Application No.: 10/823,482
Amendment dated: May 9, 2005
Reply to Office Action of February 23, 2005
Attorney Docket No.: 2802-159-036

Amendment of the Drawings:

Title: UNIVERSAL FITTING NIPPLE
Inventor(s): William Fisher *et al.*
Docket No.: 2802-159-036 / Application No. 10/823,482
ANNOTATED SHEET

Fig. 2

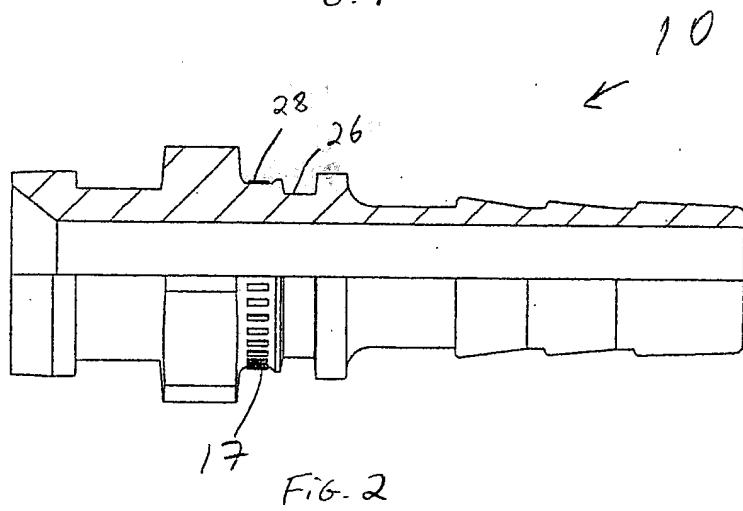
The attached sheets of drawing(s) are replacement drawings which were required from this Office Action. There are 13 replacement pages of drawings which replace the original 9 pages of drawings filed April 13, 2004, including changes to Fig. 2. This sheet, which includes Fig. 1, 2 and 3, replaces the original sheet including Figs. 1, 2 and 3. There is also an Annotated Version of Fig. 2 (changes are highlighted) included for the convenience of the Examiner.

In the Office Action, the drawings were objected to under 37 C.F.R. 1.83(a). Formal, replacement drawing sheets have been included in order to overcome this objection and to assist the Examiner with the understanding of the invention.
